Access Compliance Report

Public Rights-of-Way

Intersection ID: 12828	Main Street: W_MOREHEAD_ST	Cross Street: S_CHURCH_ST	Location: W
ADA ID: 1A6A3EBB2DDA	Ramp Type: BlendTrans2	Initial Pass/Fail: Fail	Overall Compliance: No
Severity Score: 8.75			
Codes/Mitigation Info/Possible Solution		Field Measurements/Component Compliance

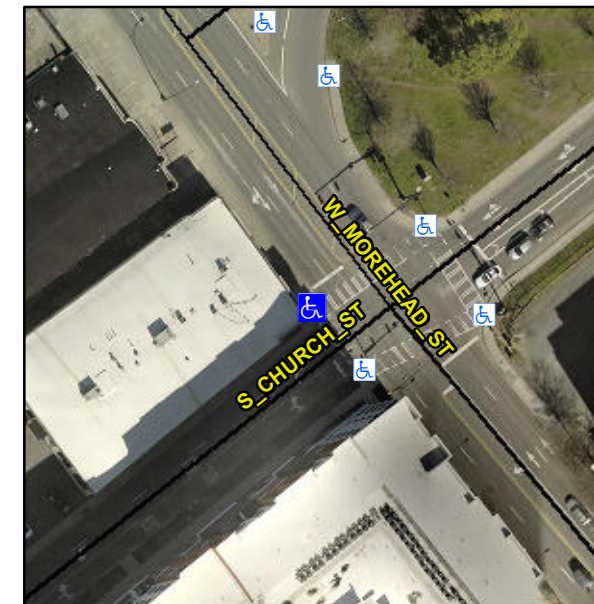
Remove & Replace Curb Ramp With Two New Directional Ramps or Equivalent.

R304.5.1
